# PEER REVIEW CONCEPT

# Peer Review Concept Design

# Peer Review Concept Design

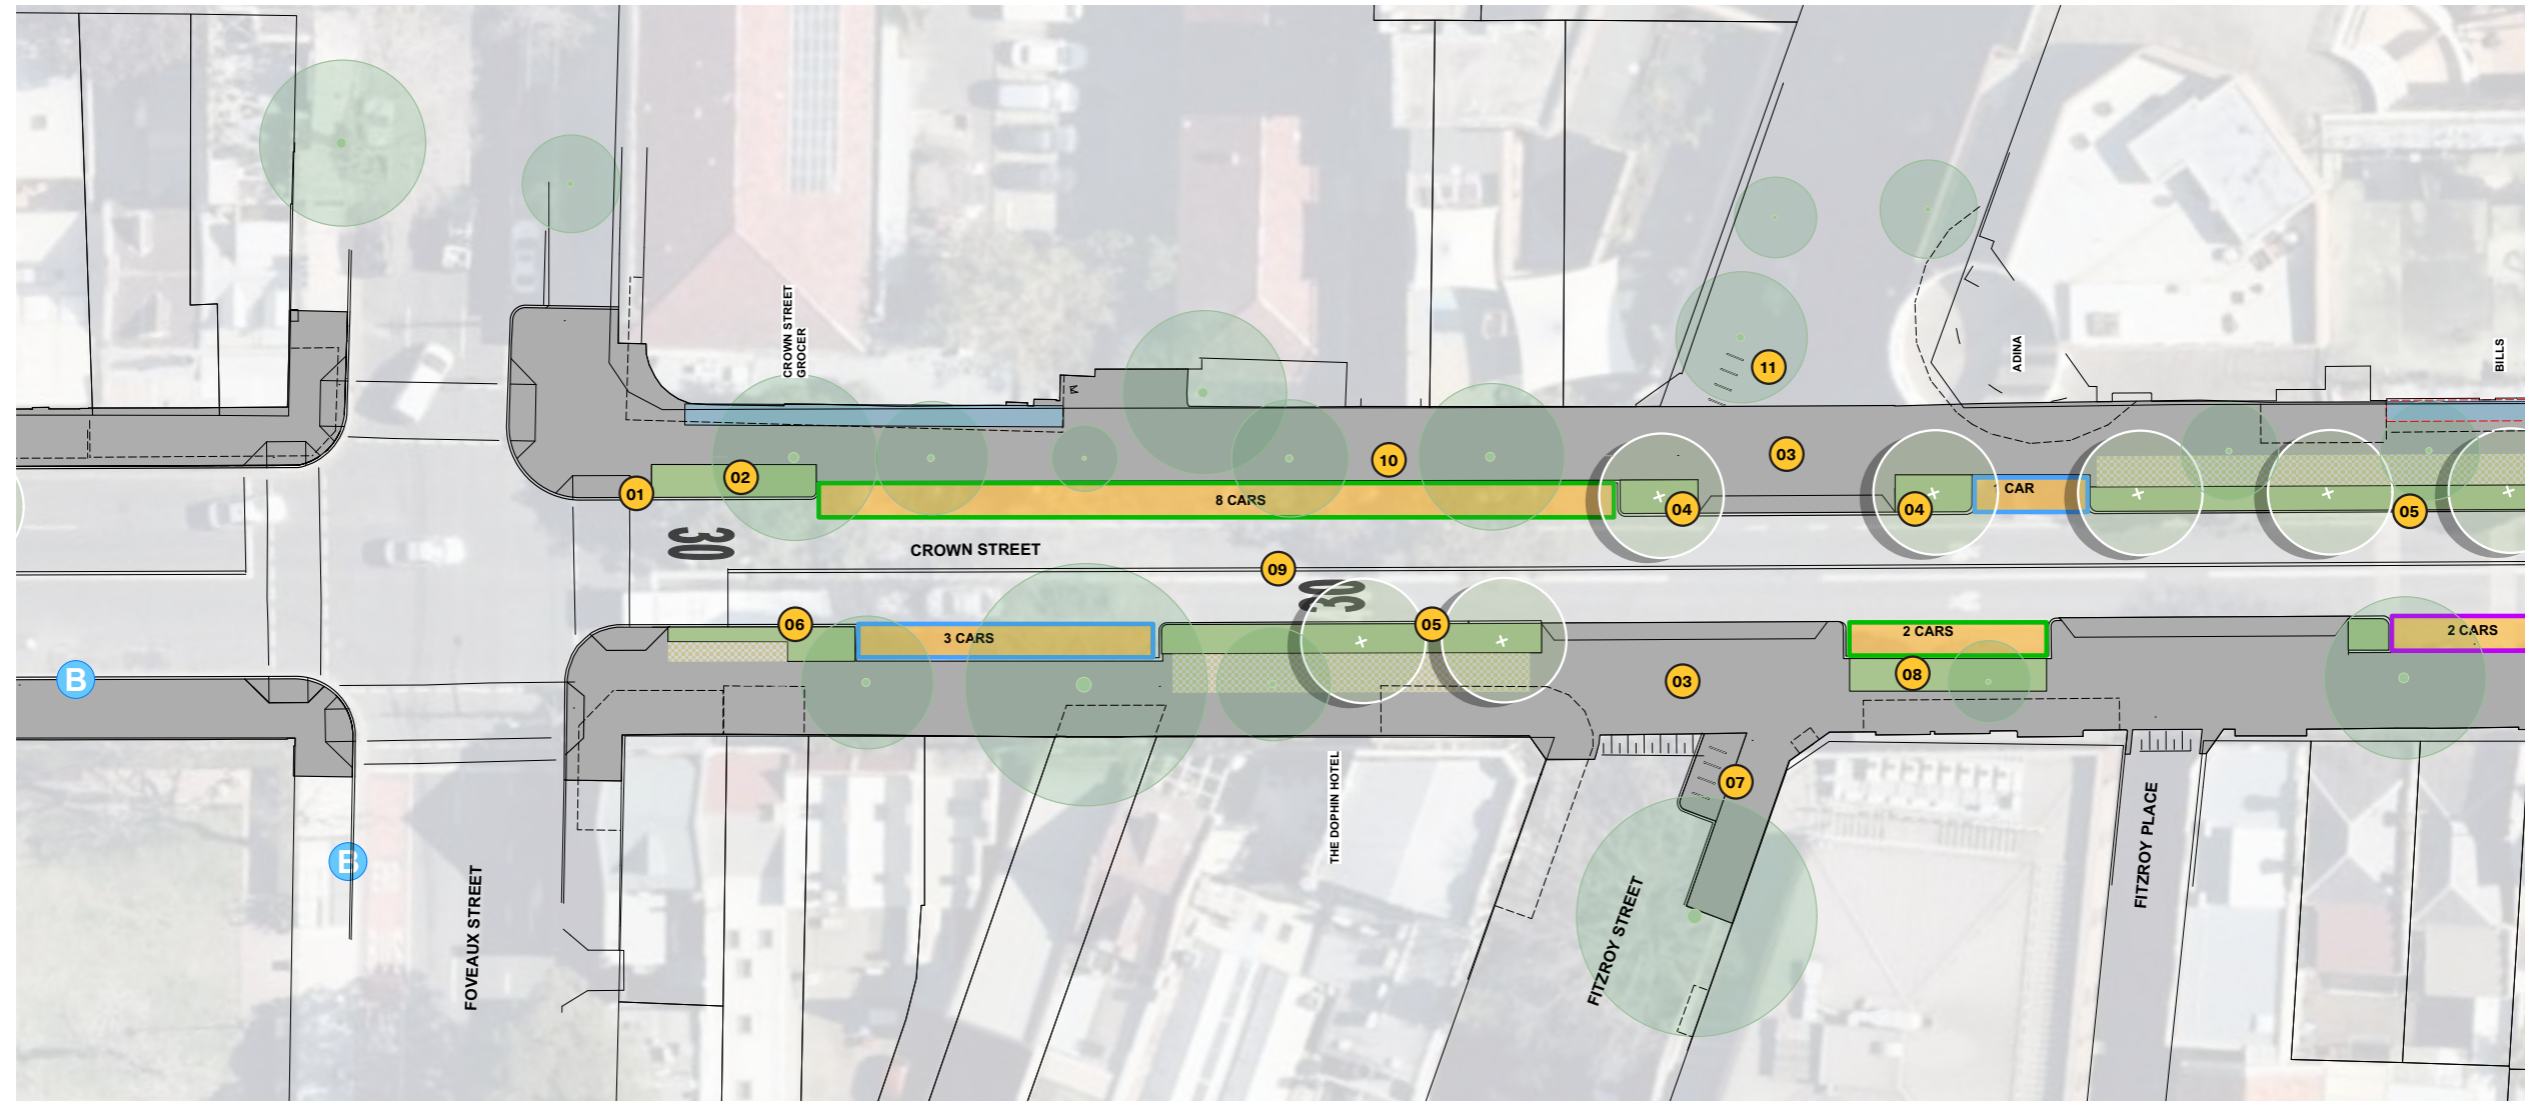
1. Kerb extension as per AECOM concept design.
2. Additional kerbside planting.
3. Continuous footpath treatment and kerb extension at Fitzroy St.
4. Kerb extension with new street tree planting.

5. New kerb extension to create activation area with kerbside planting and additional street trees at existing commercial premises.
6. New kerb extension to provide additional pedestrian paving for activation and planting. Adjustment to signal operations to be investigated (subject to TfNSW approval).

7. Kerb extension to Fitzroy Street to provide additional space for new bike parking.
8. Kerb alignment adjusted (to minimum compliant parking space width) to maximise footpath and planting space.

9. Speed reduction to Crown Street to 30km/h (subject to TfNSW approval).
10. Existing driveway removed as per current concept design.
11. Provide additional bike parking on Arthur St to offset removal/relocation of existing bike parking on Crown St.

# Peer Review Concept Design

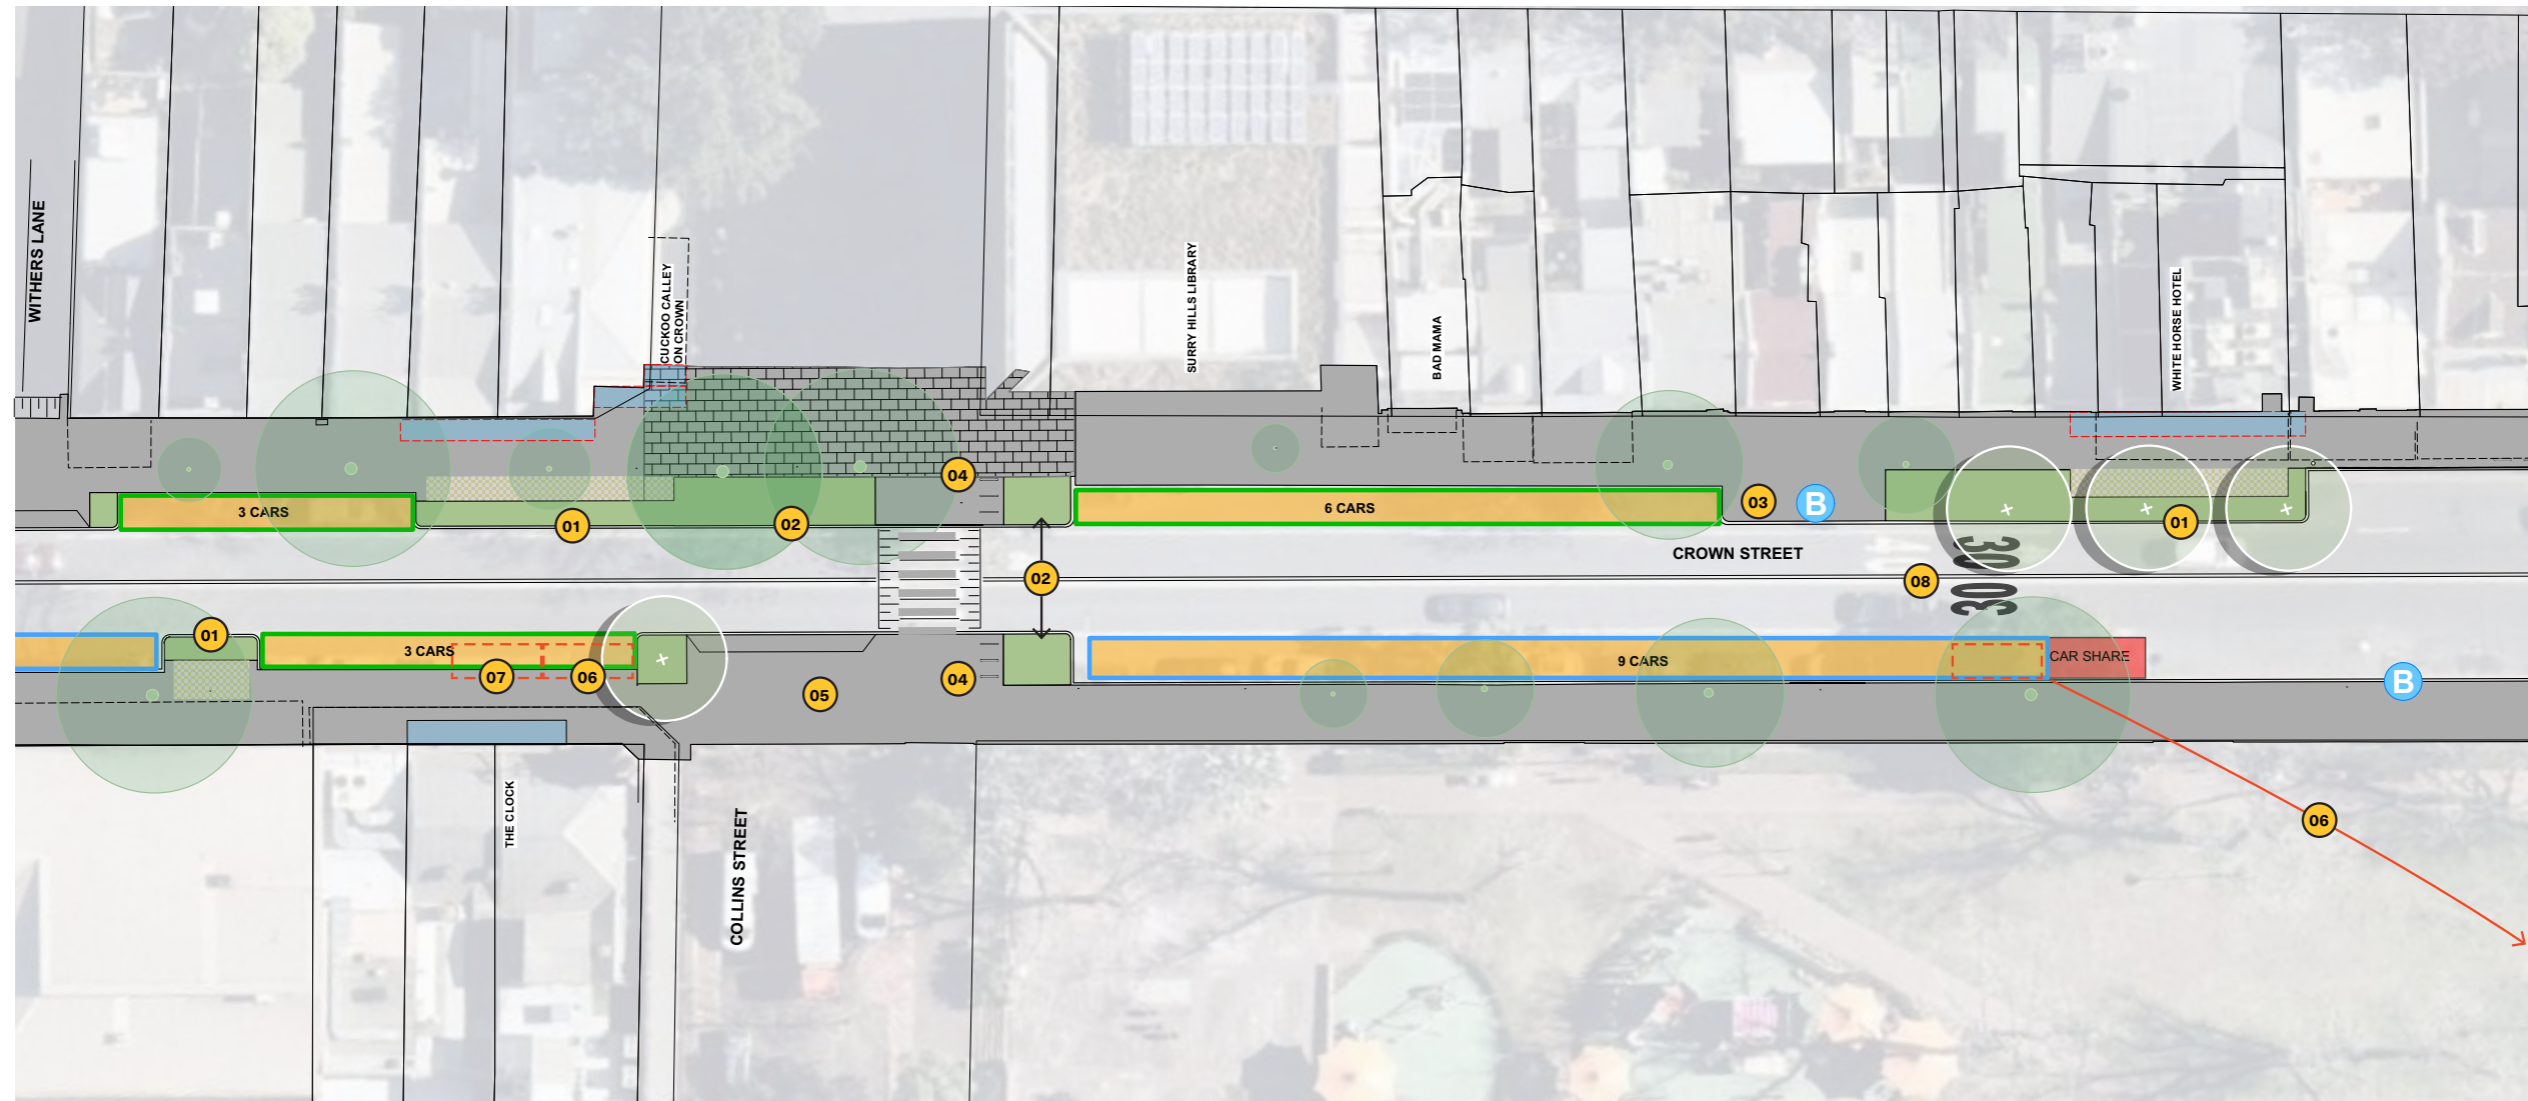
1. New kerb extension to create activation area with kerbside planting, and additional street trees at existing commercial premises.
2. New kerb extensions with additional planting (assess amenity and performance of raingarden application in main street with potential to replace with street planting consistent with approved planting palette).

3. New kerb extension for in-lane bus stop, 9m paving zone shown (to be reviewed at detailed design stage to consider user access requirements).
4. New bike parking a key arrival point to Crown St and point of dismount for cyclists approach via Crown St or Collins St.

5. Continuous footpath treatment and kerb extension at Collins St.
6. Relocate 2 no. existing car share parking spaces to Richards Ln.
7. Relocate 1 no. existing car share parking spaces to Arthur St.

8. Speed reduction to Crown Street to 30km/h (subject to TfNSW approval).

# Peer Review Concept Design

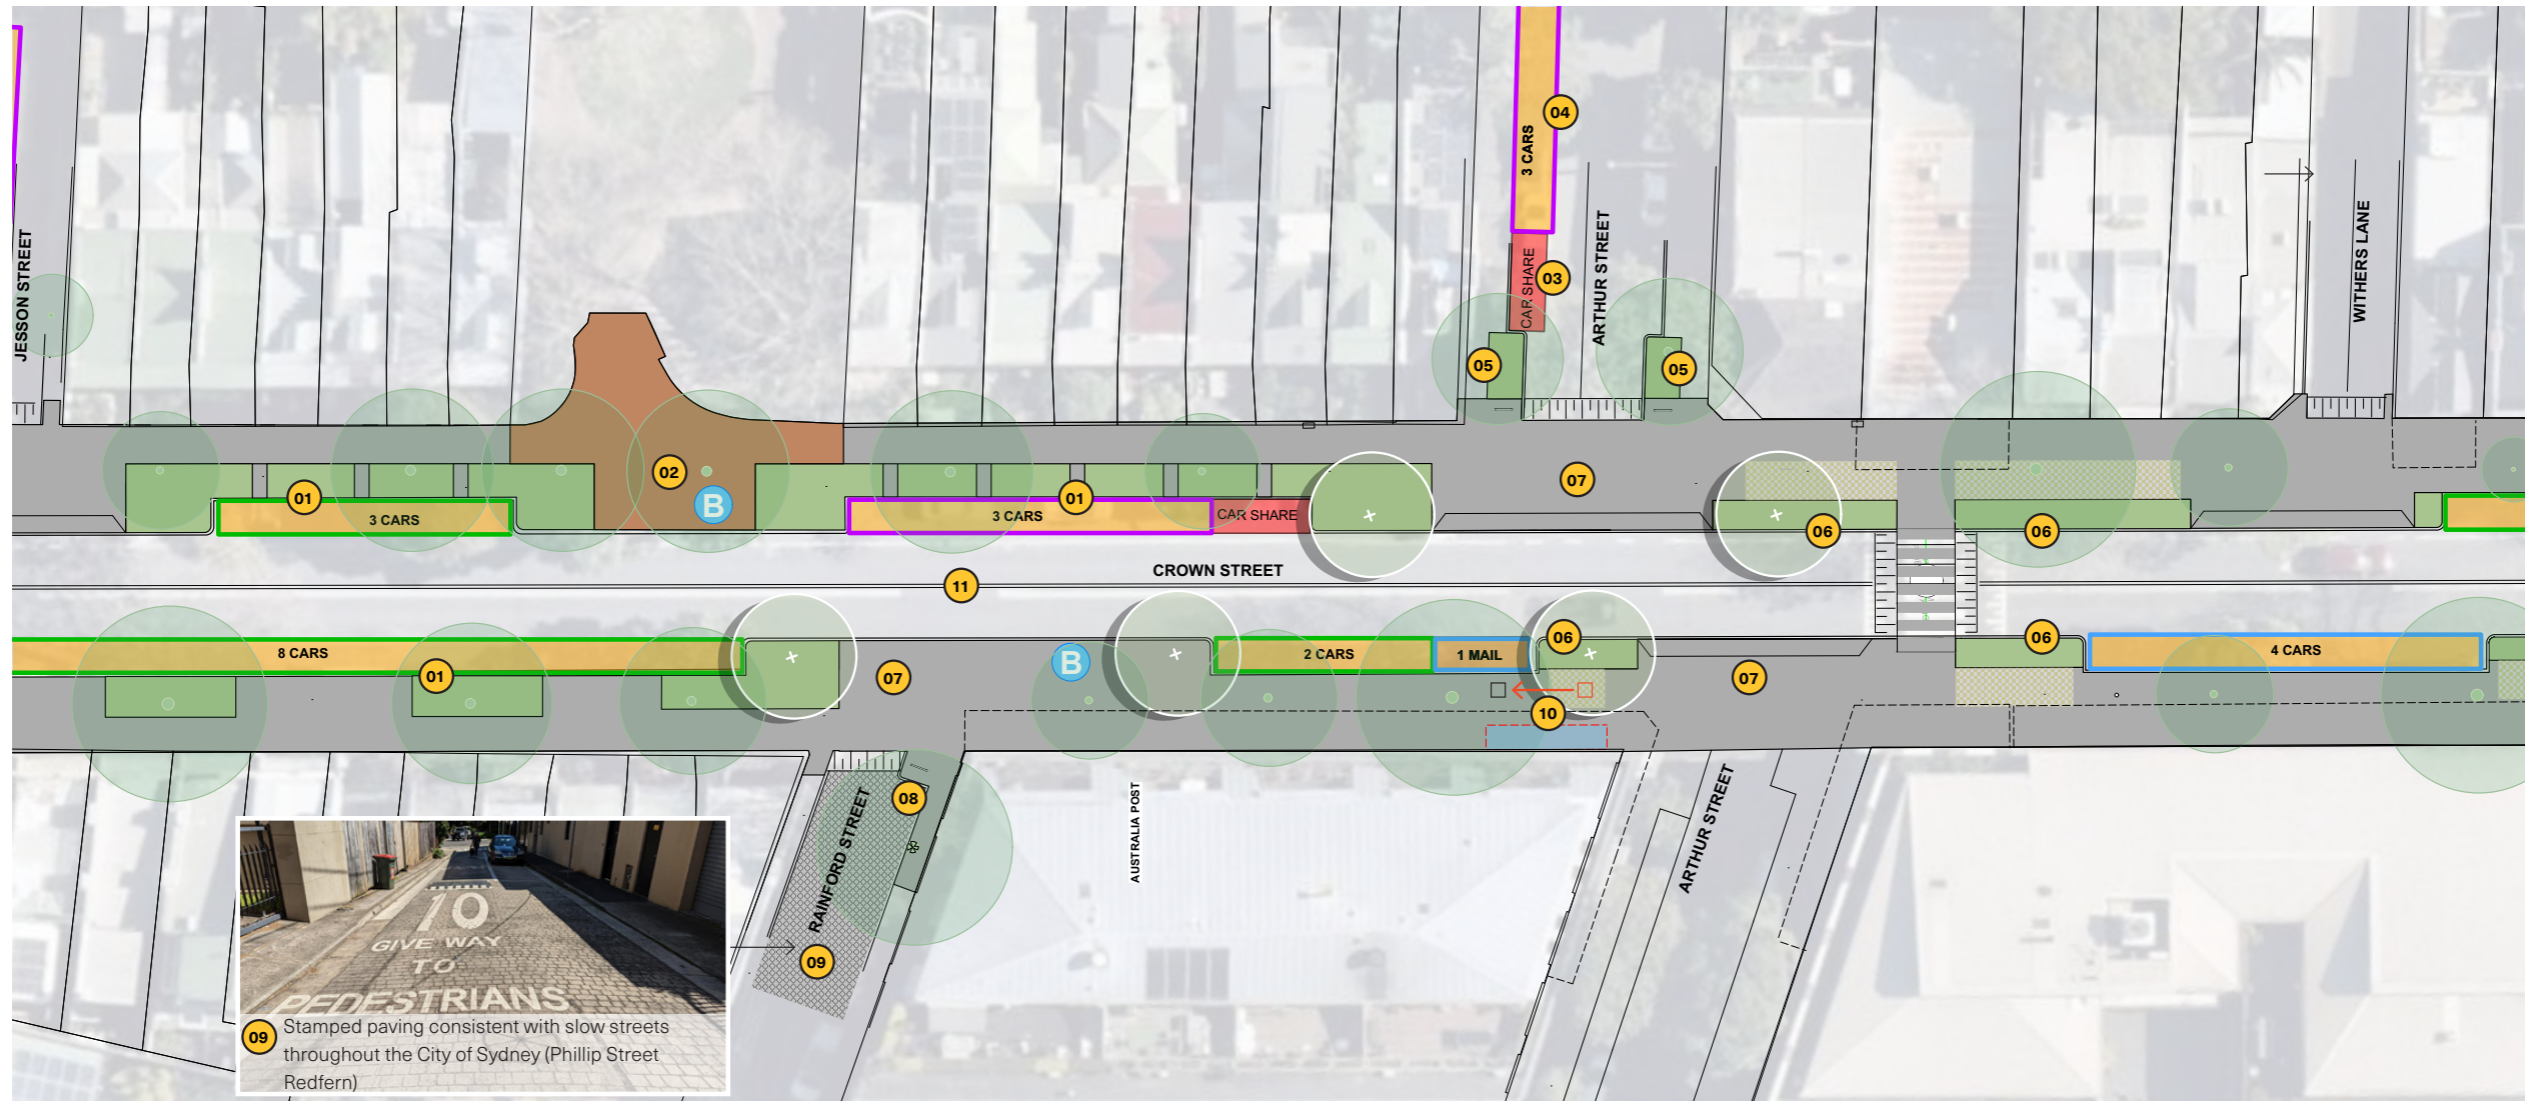
- Kerb alignment adjusted (to minimum compliant parking space width) to maximise footpath and planting space. Continuous planting bed provided with intermittent pavements for access to parked vehicles.

- Bus stop 'in the park' - in-lane bus stop located to align with Tudor St park, with existing brick paving to full width of Tudor St lot boundary to be retained.

- Relocate 1 no. existing car share parking space from outside The Clock Hotel to Arthur St.
- Convert 4 no. existing unmarked 2P parking spaces on Arthur St to 3 no. marked 2P parking spaces.

- Kerb extensions to Arthur St to provide additional space for planting and bike parking, and lane narrowing for traffic calming.
- New kerb extension to create activation area with kerbside planting, and additional street trees at existing commercial premises.

- Continuous footpath treatment and kerb extension where side streets.
- Kerb extension to Rainford St to provide additional space for new bike parking.

- New shared zone with stamped pavement to Rainford St, to be consistent with other typical City of Sydney laneway shared zones (subject to further investigation and TfNSW approval).

- Minor relocation of existing mail box to provide additional activation area.
- Speed reduction to Crown Street to 30km/h (subject to TfNSW approval).
